New Reg: Towards Consumer-Centric Energy Network Regulation

AusNet Services' Trial

Note for the Customer Forum on AusNet Services' negotiating position notes

Figure 1 Proposed change in annual Revenues, 2016-20 to 2021-25

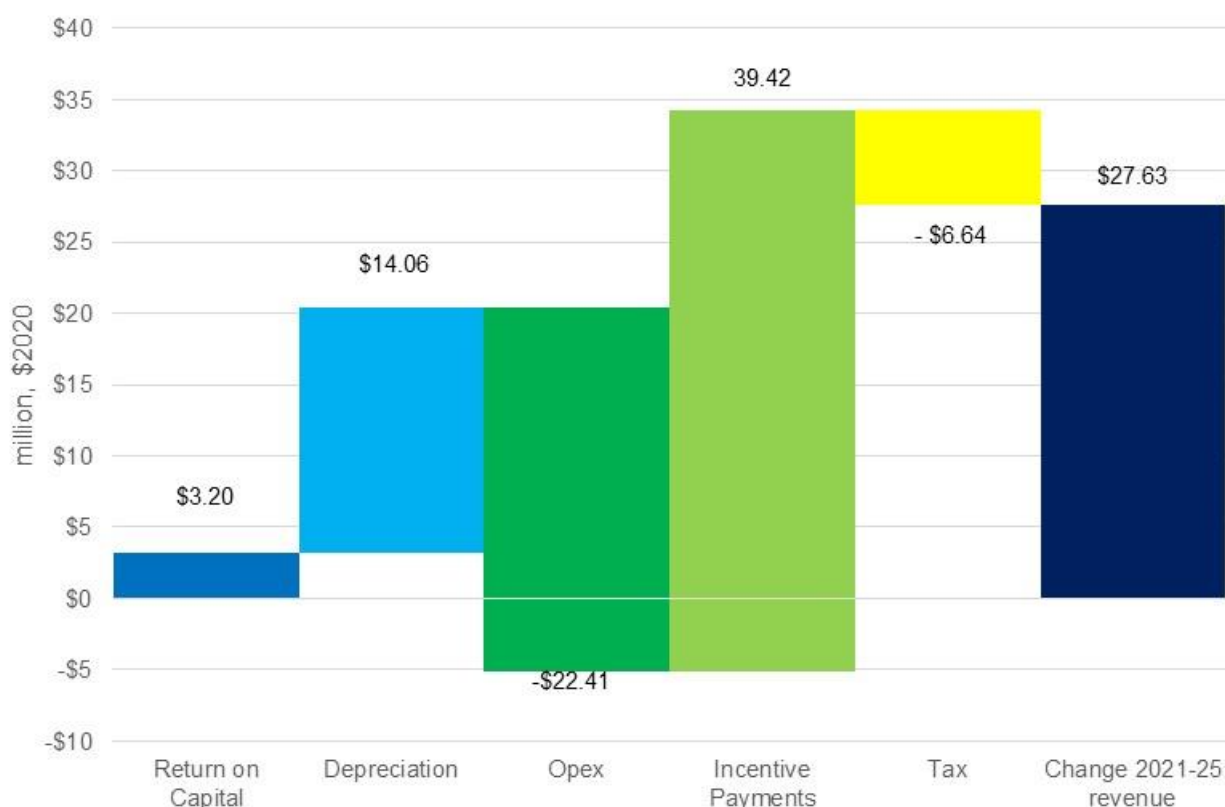
There are a number of factors that are driving the changes in Figure 1:

- AusNet’s models currently include a rate of return which looks consistent with our draft rate of return guideline.⁴ The nominal vanilla rate of return for the first year of the 2021-25 regulatory period is 5.79% which is a reduction from the 6.31% rate of return in the AER’s determination for 2016-20. This results in an average annual revenue reduction of \$24.7 million, or 3 per cent.
- AusNet’s models also adopt the AER’s draft rate of return guideline position on a parameter that affects AusNet’s tax building block (the value of imputation credits). This results in a reduction of \$5.7 million, or 1 per cent, from what revenues would have been using the previous value.

- AusNet’s capex is driving the increase in both the return on and of capital despite proposed capex being lower in real terms. There are three reasons for this:

- Capex from 2016-20 mostly occurs at the end of the period meaning that more depreciation on this capex is recovered in 2021-25.
 - Proposed capex for 2021-25 is mainly planned during the first three years of the period meaning more of it will be depreciated during the 2021-25 period and the return will be earned on this larger RAB over the full regulatory period.

- AusNet is proposing to substantially increase IT capex which is depreciated over a shorter period (5 years in this case).
- AusNet’s incentive payments are increasing:

Figure 2 Average annual change in AusNet’s capex categories

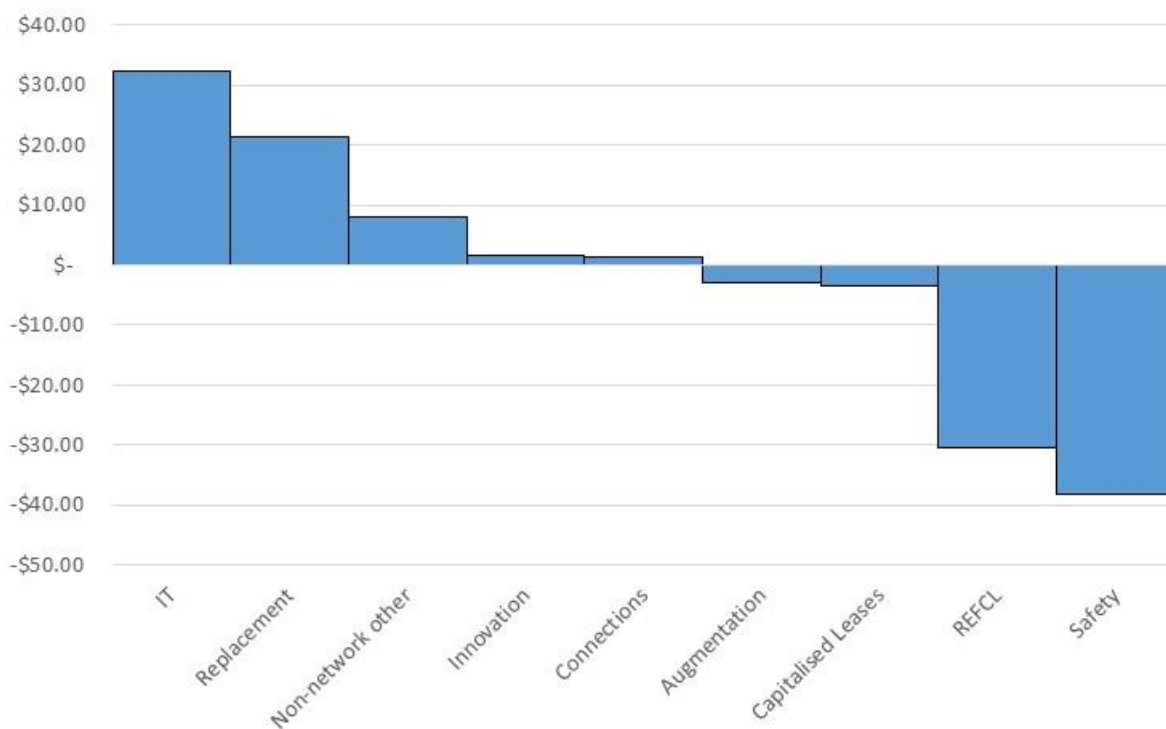
Overall, average annual capex is around \$10 million lower than the previous regulatory period. This is mainly a result of lower capex for safety measures (reduction of \$38 million per year) and the REFCL programme (\$30 million per year) offsetting higher replacement capex (additional \$21 million per year) and IT related capex (\$32 million per year). Figure 2 shows the movements in the different capex categories.

Figure 3 IT Capex

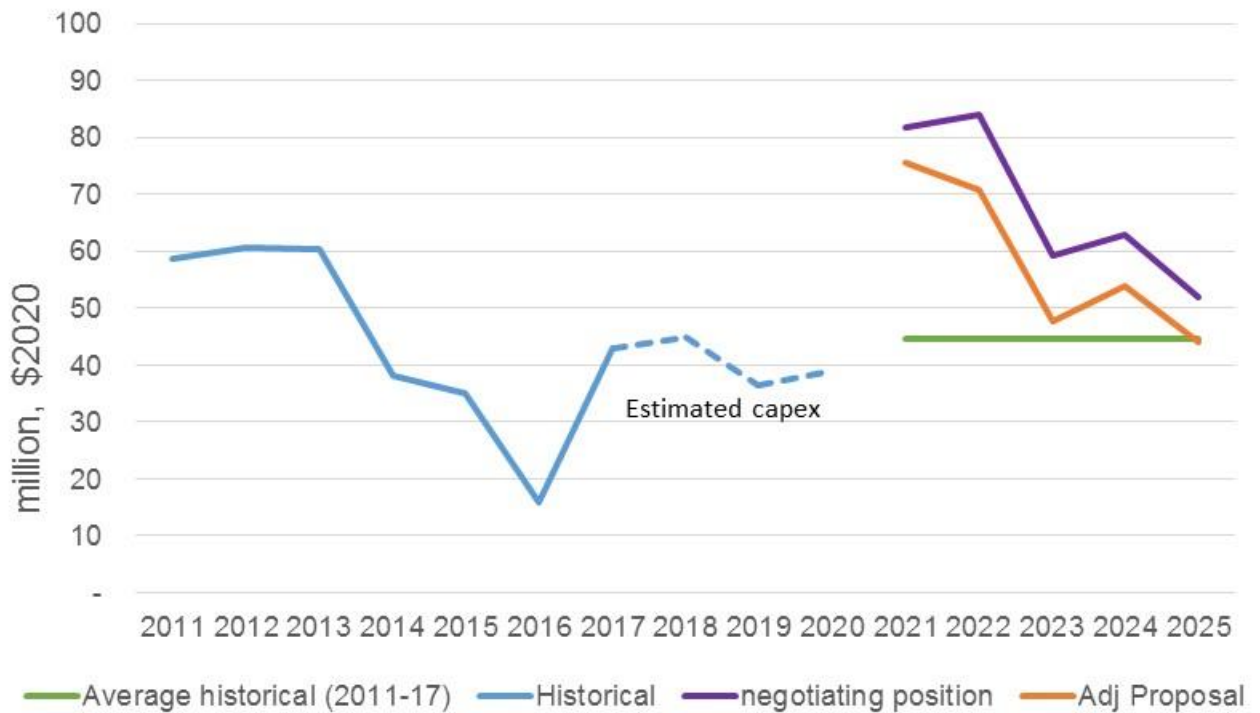
AusNet is proposing an increase in IT capex. Figure 3 presents AusNet’s forecast capex against its historical capex and average annual IT capex from 2011 to 2017. The proposed IT Capex for 2021-25 represents a 53% increase on average annual IT costs between 2011 and 2017. IT capex has a material impact on the revenue that AusNet is seeking from customers because it depreciates over a short period of time (5 years) compared to other capex (which can have asset lives up to 50 years). If, AusNet instead proposed its historic average IT capex for 2011-17, its distribution revenues would be 14.1 million, or 2 per cent, less per annum.

These re-allocations make it difficult to compare proposed capex with historical capex¹¹. The orange line in Figure 3 shows forecast capex without these reallocations. This forecast capex is still on average 8.3 per cent higher than average actual capex for 2011-17.¹²

Figure 4 Composition of IT Capex 2021-25

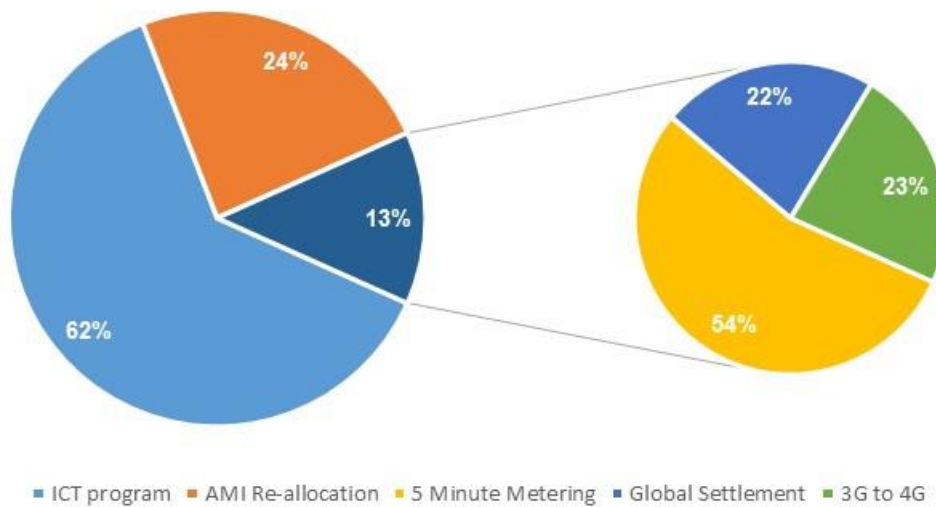
Figure 4 presents the different components of AusNet’s forecast distribution IT capex, with the new capex programs separated (step changes and reallocation of AMI IT Capex from metering). The step changes are for shifting from 3G to 4G, 5 minute metering and global settlement. Figure 4 shows the composition of forecast IT capex.

Figure 6 How costs are shifting from AusNet’s base year (\$ per residential customer)

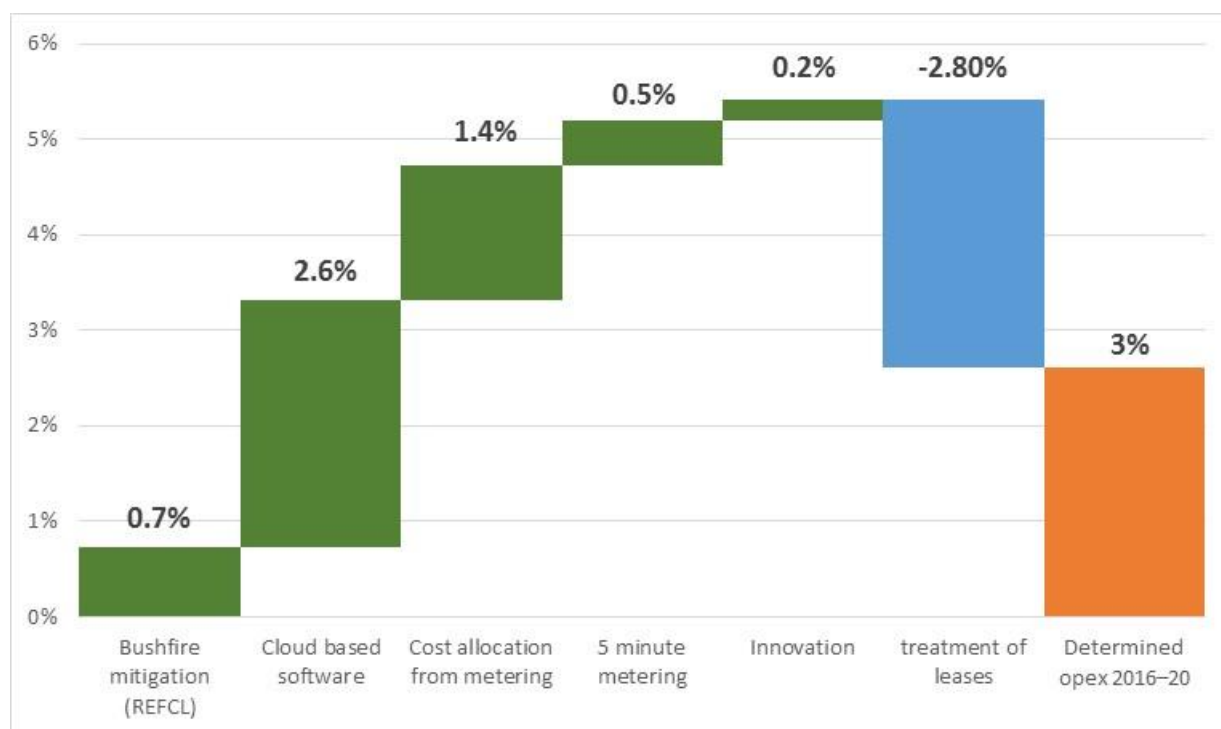
Step changes account for the major drivers of increases in AusNet's expenditure from its 2018 base year. Figure 6 shows that there are a number of step changes proposed by AusNet.

Our comments below are based on the description of each step change provided by AusNet in its guidance note. We consider that further information would be required for a proper evaluation of the step changes. In making our determinations we would request justification for the need for the step changes against the criteria for assessing step changes set out in our expenditure forecast assessment guideline.³⁴ This aside, we make the following observations:
